**MEMORANDUM**

REVIEW TYPE: **Site Plan Review**
 CASE #: **820060160**
 PROJECT NAME: Danshes Property
 APPLYING FOR: Approval of 40 dwelling units including 34 one-family detached dwelling units and six MPDUs (townhouses) on 92 acres of land in the RNC Zone.

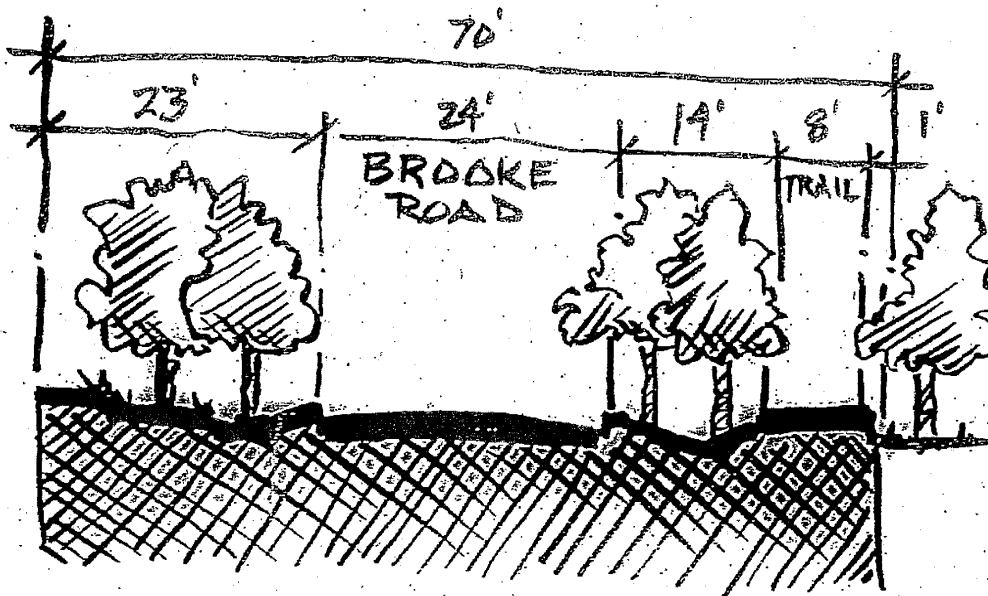
The cross-section shown below is recommended for Brooke Road. It features landscaping on either side of an 8' asphalt trail to create a sense of enclosure and to provide a natural setting.
